**JOINT REGIONAL PLANNING PANEL  
(East)**

<b>JRPP No</b>	2016SYE047
<b>DA Number</b>	DA2016/0052
<b>Local Government Area</b>	Georges River Council
<b>Proposed Development</b>	Demolition of existing structures and construction of a residential flat building containing 21 units and basement car parking (Crown Application)
<b>Street Address</b>	53 – 57 Lawrence Street Peakhurst
<b>Applicant/Owner</b>	Applicant: NSW Land and Housing Corporation  Owner: NSW Land and Housing Corporation
<b>Number of Submissions</b>	22 adjoining and adjacent owners/residents notified Application advertised for fourteen (14) days No submissions were received
<b>Regional Development Criteria (Schedule 4A of the Act)</b>	Value over \$5M and Crown Application (\$6,981,443.00)
<b>List of All Relevant s79C(1)(a) Matters</b>	<ul style="list-style-type: none"> <li>▪ Hurstville Local Environmental Plan 2012</li> <li>▪ Greater Metropolitan Regional Environmental Plan No 2 – Georges River Catchment</li> <li>▪ State Environmental Planning Policy No 55 – Remediation of Land</li> <li>▪ State Environmental Planning Policy (Building Sustainability Index (BASIX) 2004</li> <li>▪ State Environmental Planning Policy No 65

*Diagram of height encroachment*

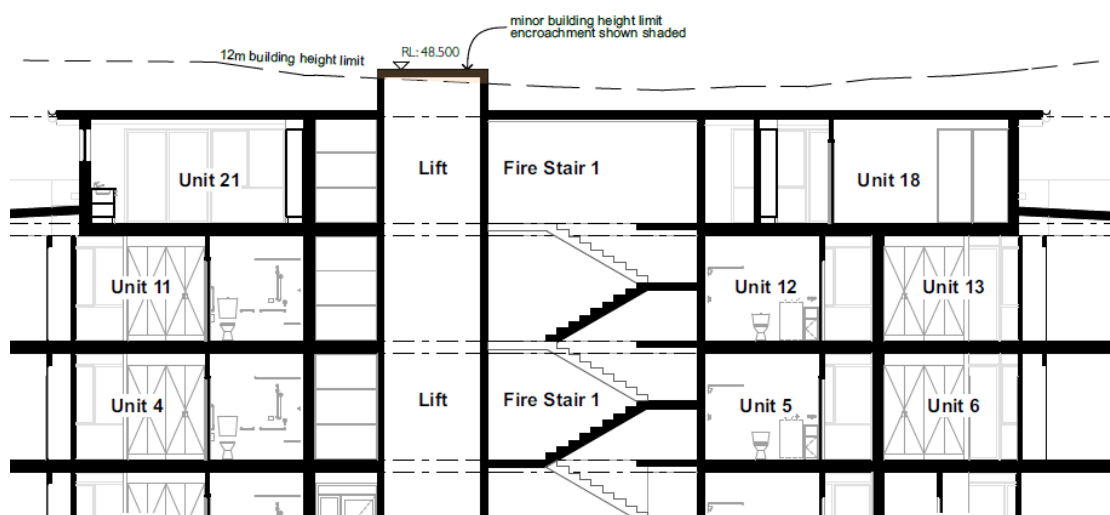
*Scale is generally acceptable. However, the Panel note that there are a number of minor breaches of the height plane cause by exaggerated parapet features. It is recommended that the frames proposed around the projecting balconies lower the height of their top component to avoid the breaching of the height plane.*

*The design of the roof and projecting balconies have been revised such that only the lift overrun component of the building exceeds the building height plane, as demonstrated on the revised architectural plans. The orientation of the building is determined by the orientation of the site and to achieve the required levels of solar access for the dwellings within the development. The proposal achieves the objectives of the DCP control given that adequate landscaping opportunities are provided; visual and acoustic privacy will not be unreasonably impacted given the minor nature of the encroachments; solar access to adjoining properties is not unreasonably reduced as demonstrated on the submitted shadow diagrams; and the development will not result in detrimental impacts on the attractiveness of the streetscape.*

Diagram showing the fourth storey in red

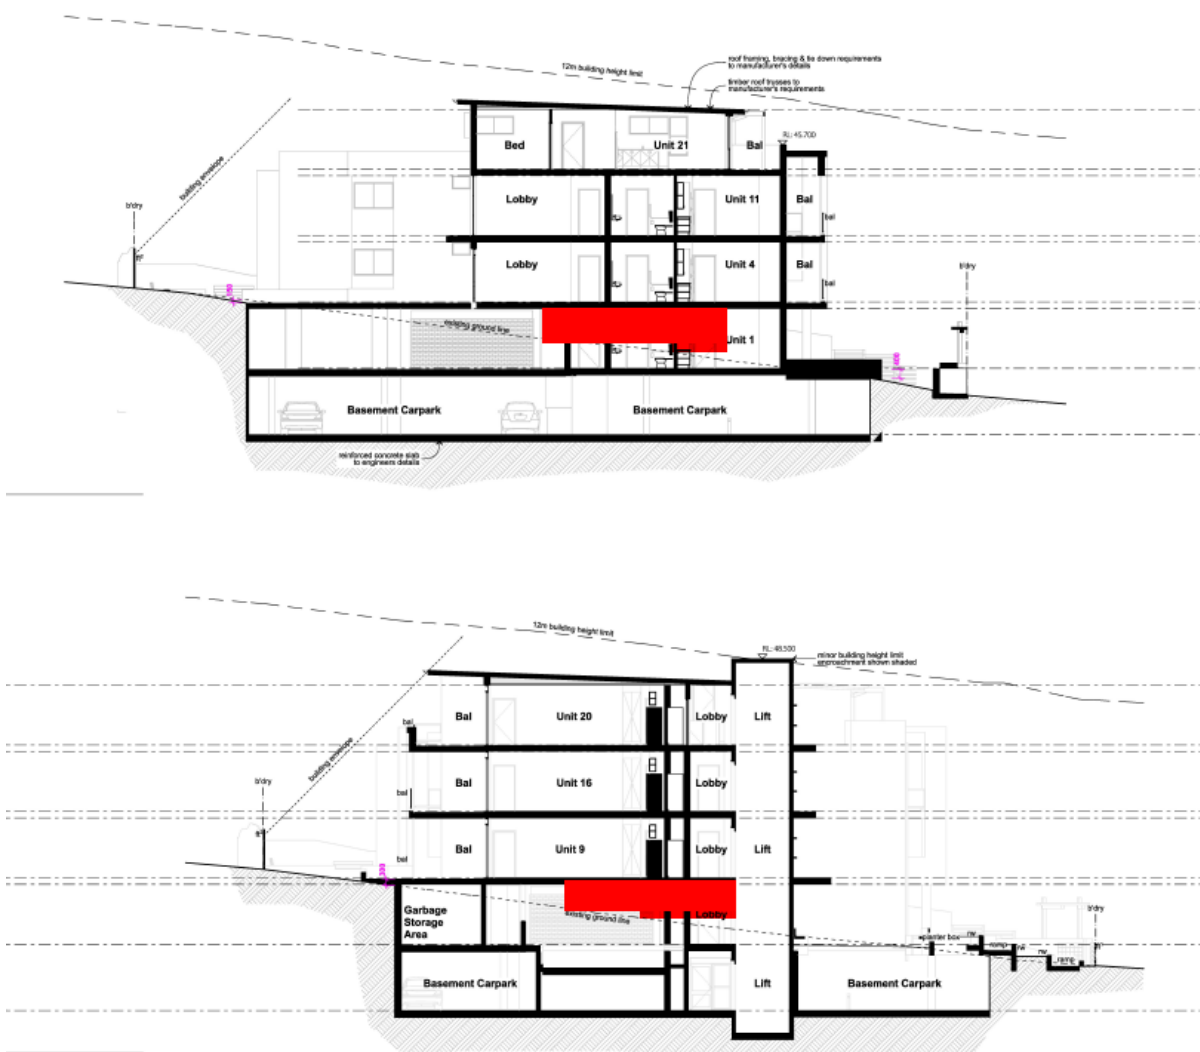
The proposed development seeks a variation to the number of storeys, excavation, and basement parking area. The variation to these requirements is a result of the topography of the site which has a significant slope to the front of the site. To address this issue the applicant has provided a basement level which sits wholly within the ground and an upper basement level to part of the site which requires the height to be up to 1.92m above ground level. The excavation proposed to the site is at the perimeter of the building so to provide a level slab for the ground level. The diagram below identifies in red where the development is defined as being 4 storeys. This is in the middle of the site where there is a transition between the highest and lowest part of the site.

The variations are considered acceptable as they do not result in additional impacts to the adjoining developments in terms of privacy and solar access. The ground level around the building has been maintained with landscaped open space areas being at the existing ground level. The development generally achieves or exceeds compliance with the relevant requirements and has a floor space ratio below the maximum requirement. As such the variations are not a result of an overdevelopment of the site.

## (2) Minimum Side Boundary Setbacks

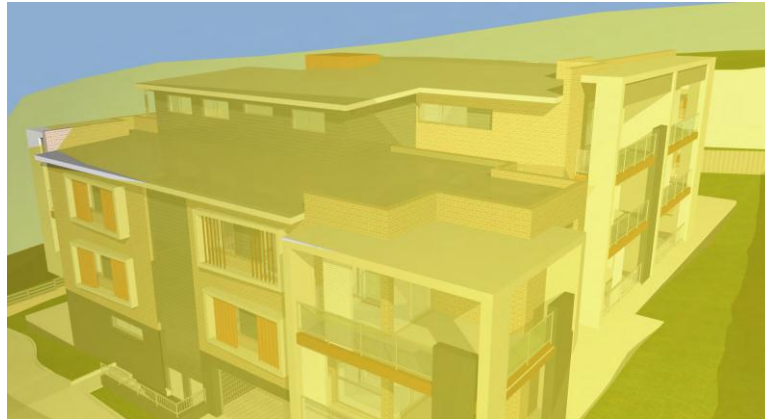
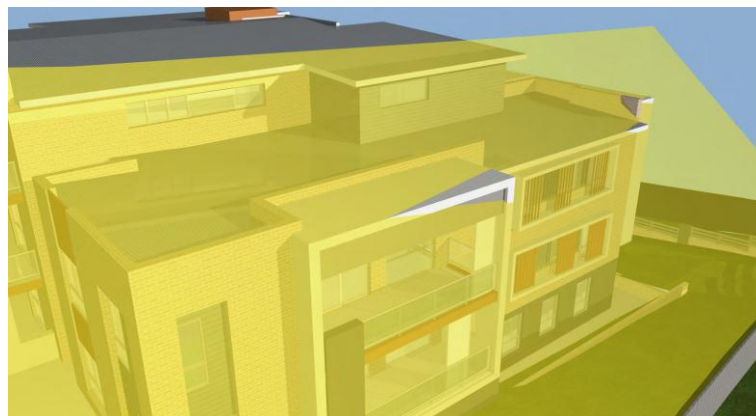
The proposed development encroaches into the building envelope for a minor part of the east and west elevation as shown in the diagrams below. The encroachment is negligible and does not result in any adverse impact on the adjoining developments or the bulk and scale of the development. It is noted that the development provides separation distances in excess of the requirements of the ADG and as such the encroachment into the building envelope is not a result of the building being closer to the side boundaries.
